Product Change Notification: E-18-004623

General Product Description:  
DEUTSCH Size 12 and 16 Sealing Plug.

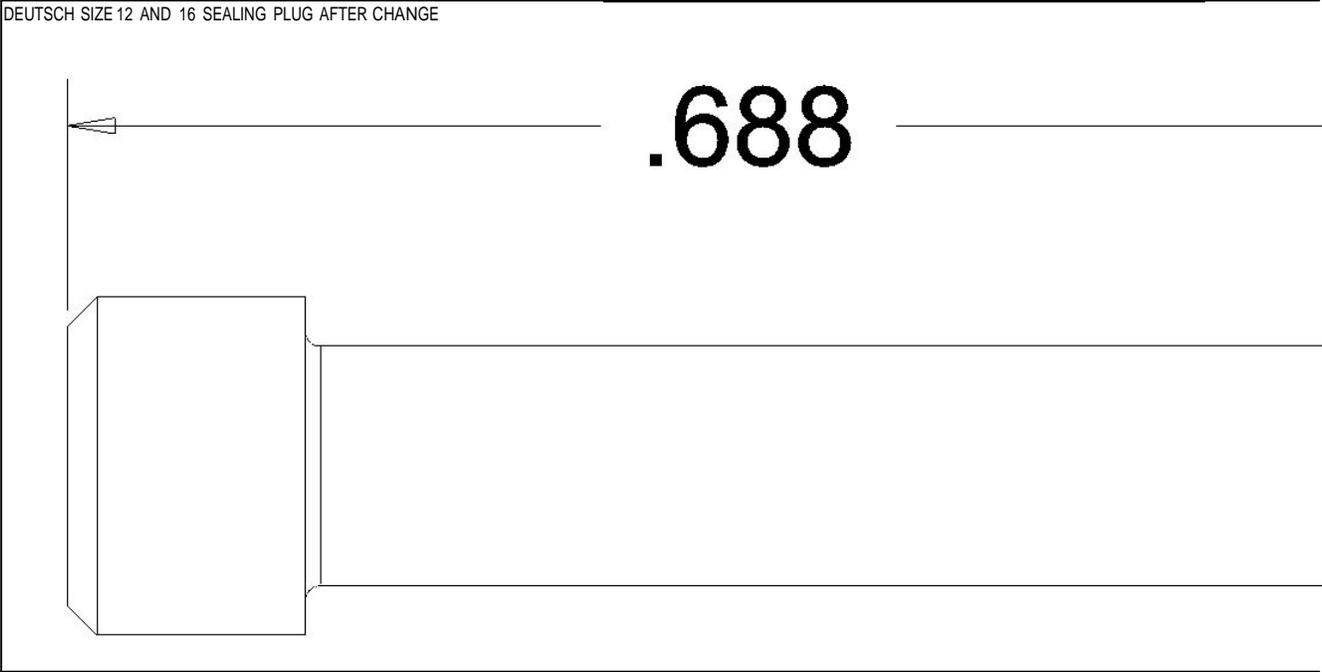
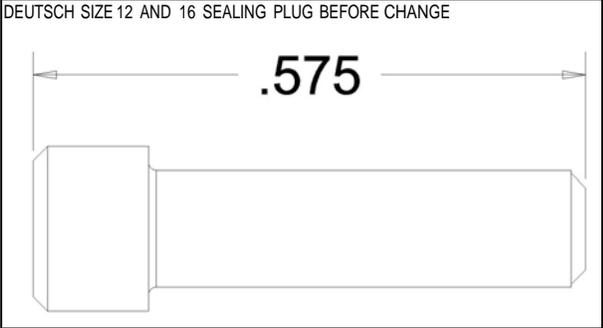
Increase the overall length of the sealing plug from .575 to .688

Reason for Changes:  
Product Improvement. Dear Customer, in an effort to continuously improve our products, TE will be changing the overall length of the Size 12 and 16 sealing plug in order to improve robustness in connectors with rear accessories such as end caps or wire routers. This product improvement will not impact other areas of sealing plug performance. Shipments of both configurations may be mixed. IMPORTANT: This is a continual improvement so the current and previous revisions of this part can be used interchangeably in the field. This change is being phased in gradually and previous revision can remain stocked until used.
